UNITED STATES
DEPARTMENT OF THE INTERIOR
BUREAU OF LAND MANAGEMENT

FORM APPROVED
OMB NO. 1004-0135
Expires: July 31, 2010**SUNDRY NOTICES AND REPORTS ON WELLS**
*Do not use this form for proposals to drill or to re-enter an abandoned well. Use form 3160-3 (APD) for such proposals.*5. Lease Serial No.
NMMN037489

SUBMIT IN TRIPLICATE - Other instructions on reverse side.8. Well Name and No.
COTTON DRAW UNIT 115H9. API Well No.
30-015-37898-00-S110. Field and Pool, or Exploratory
COTTON DRAW11. County or Parish, and State
EDDY COUNTY, NM

Temporary Abandonment of Wells on Federal Lands
Conditions of Approval

Well Name: COTTON DRAW UNIT 115H		Field: AVALON SHALE	
Location: 330' FSL & 1650' FEL; SEC 34-T24S-R31E		County: EDDY	State: NM
Elevation: 3472' KB; 3447' GL; 25' KB to GL		Spud Date: 9/28/10	Compl Date: 03/09/11
API#: 30-015-37898	Prepared by: Ronnie Slack	Date: 4/20/16	Rev:

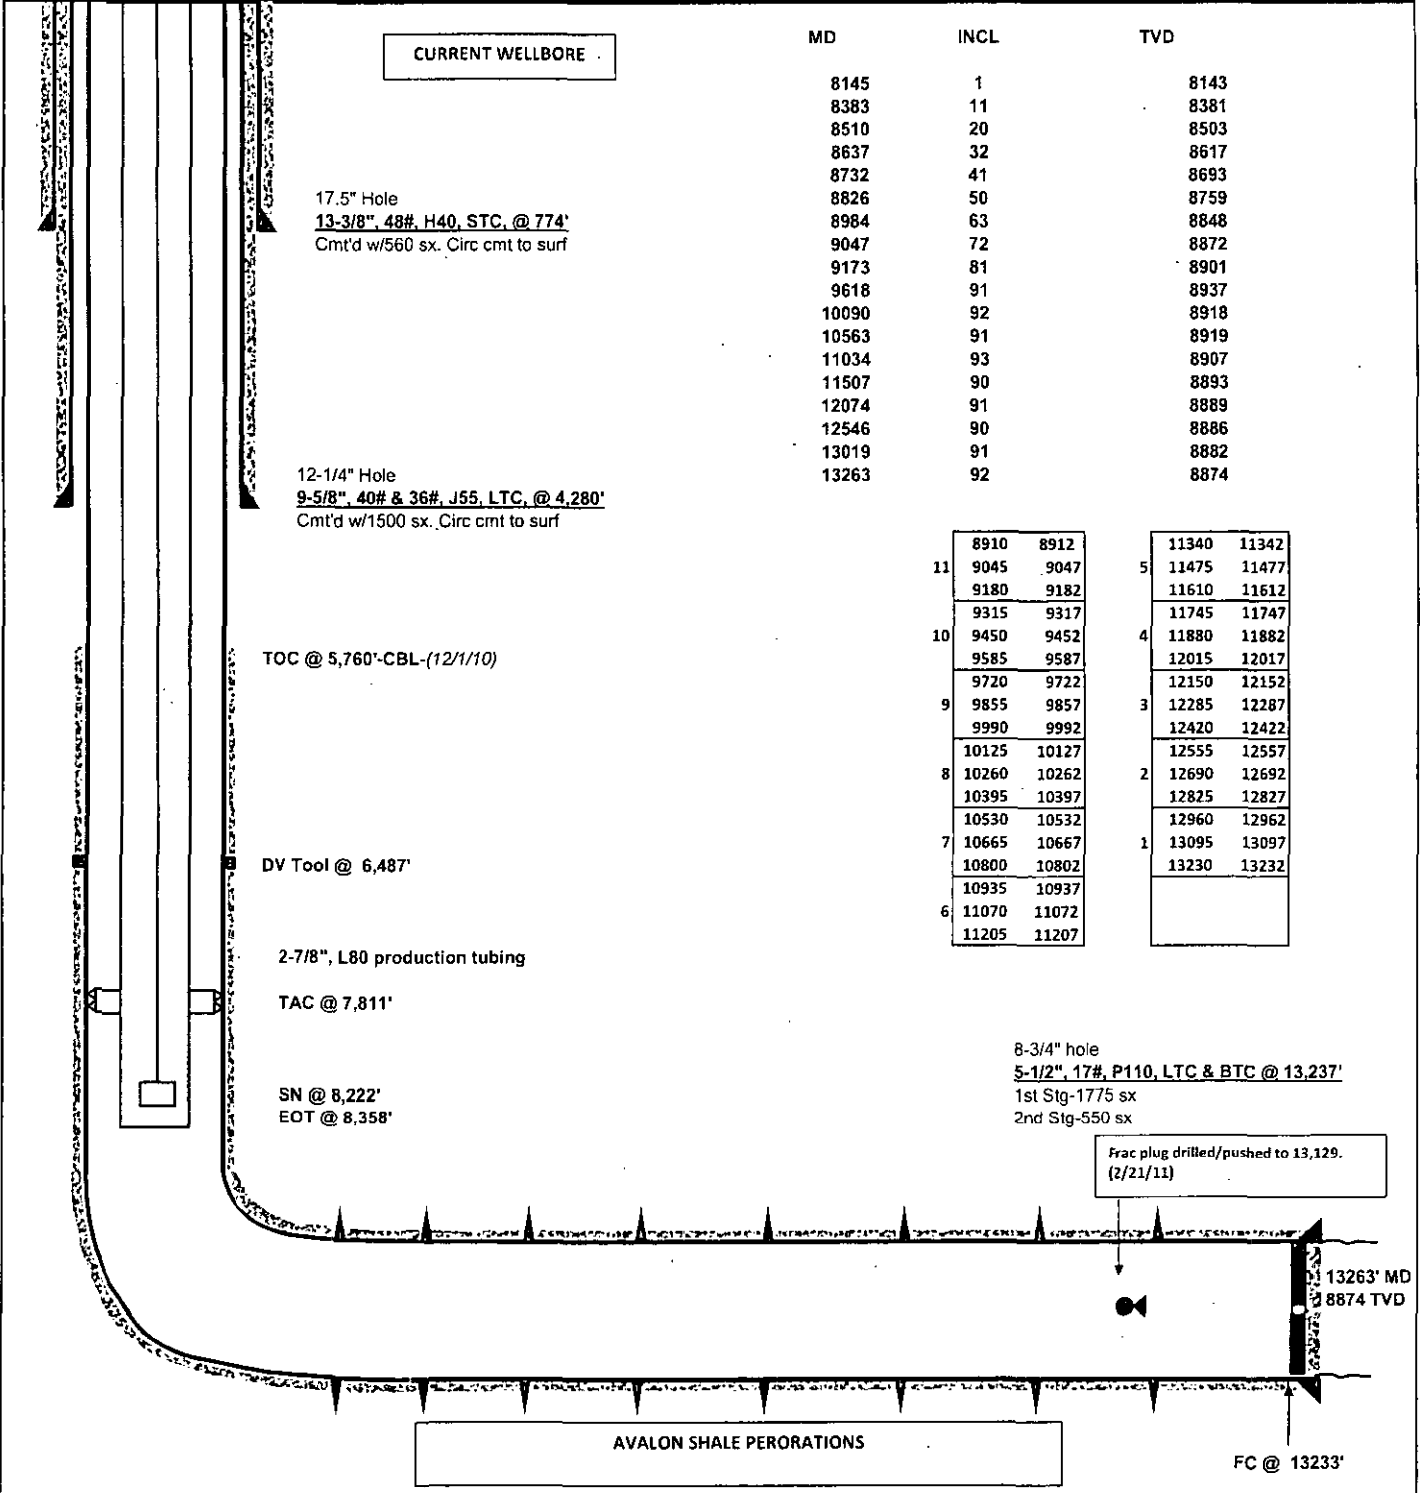
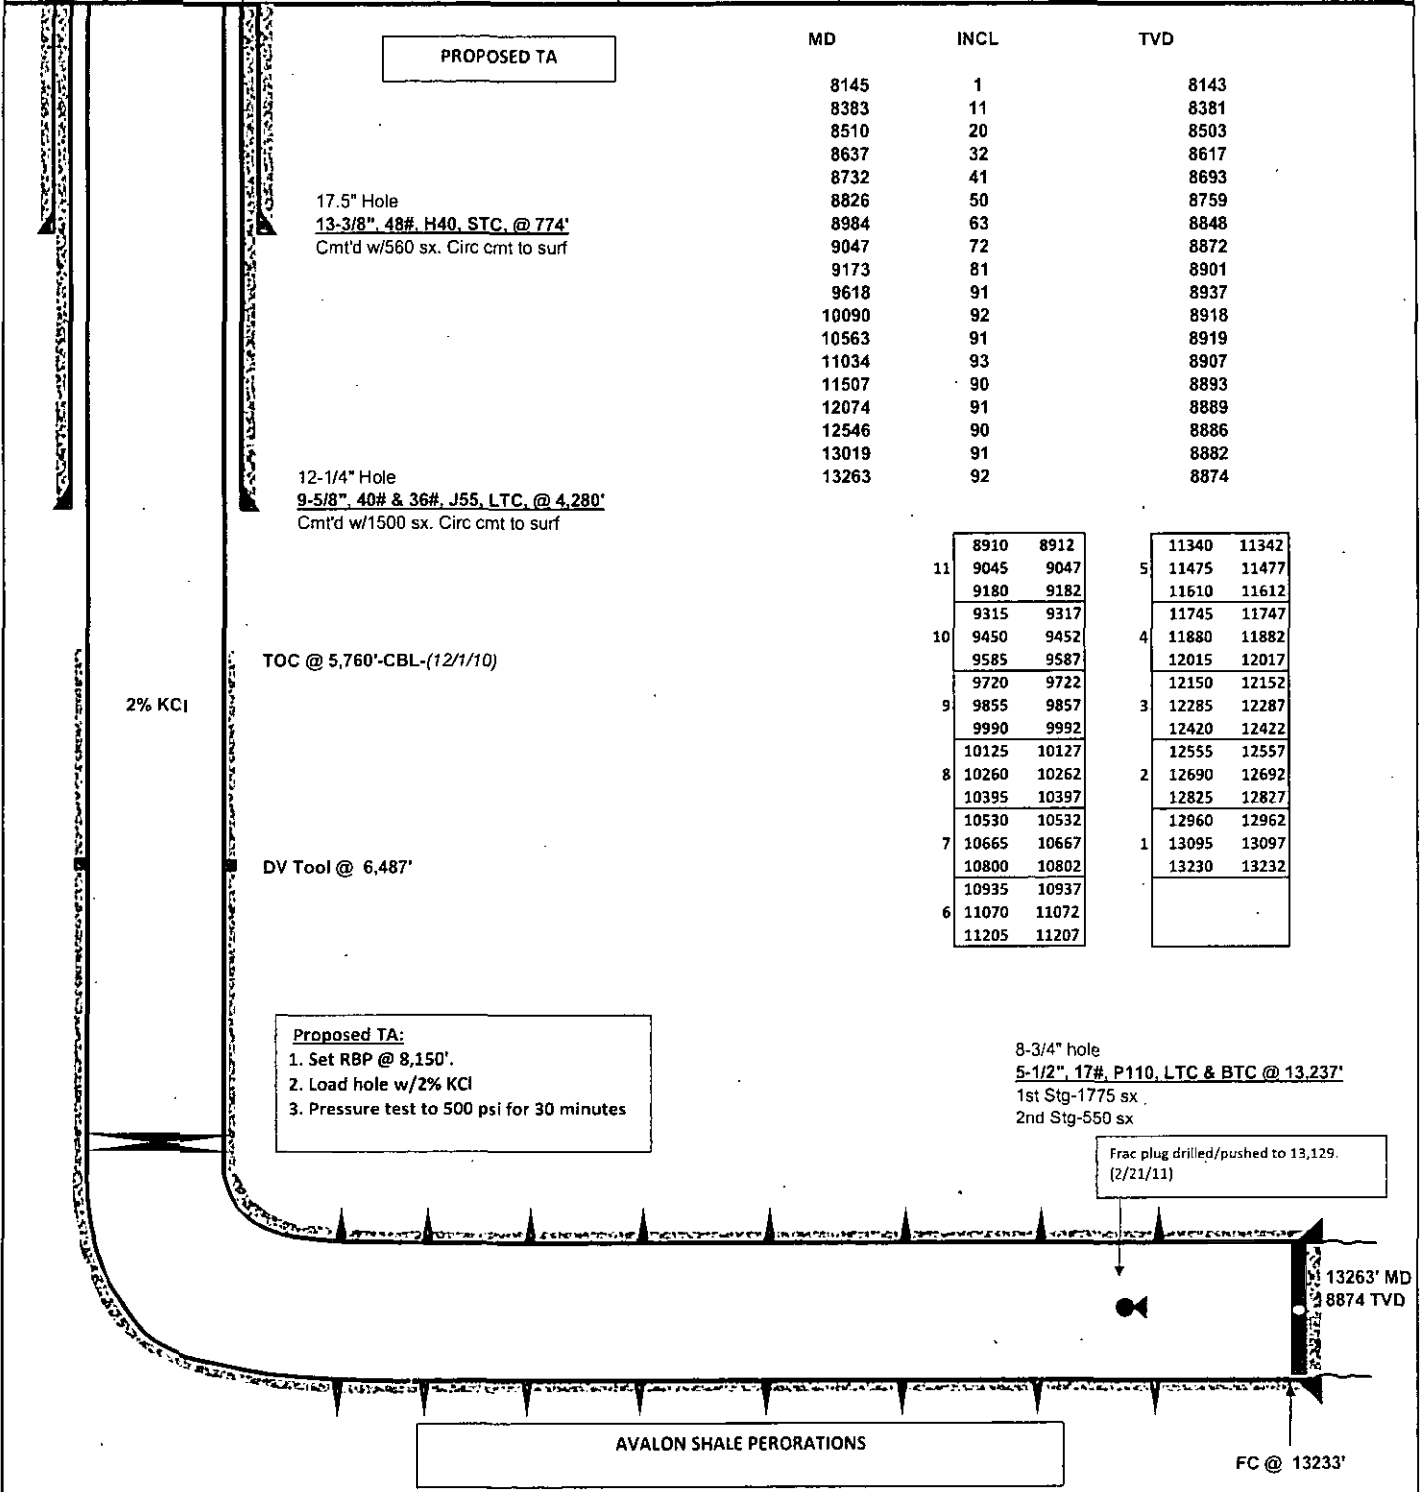
ATTACHMENT: PROCEDURE & WELLBORE SCHEMATIC

1. MIRU WSU.
2. ND Wellhead. NU BOPE & test.
3. POOH W/rod pump assembly and 2-7/8" production tubing from ~8,358'.
4. Make gauge ring/junk basket run to ~8,150'.
5. RU W/L. Set RBP @ 8,150'.
6. TIH w/2-7/8" tubing to ~8,100'. Load and circulate hole w/2% KCl w/corrosion inhibitor.
7. Pressure test casing to 500 psi for 30 minutes. Chart test and have BLM / NMOCD witness.
8. Bleed off pressure. ND BOPE. NU wellhead.
9. RDMO WSU.

1. Well may be approved to be TA/SI for a period of 12 months or until 5/31/2017 after successful MIT and subsequent report is submitted.
2. This will be the last TA approval for this well.
3. Contact BLM 24 Hrs. prior to setting of plugs so as it may be witnessed.
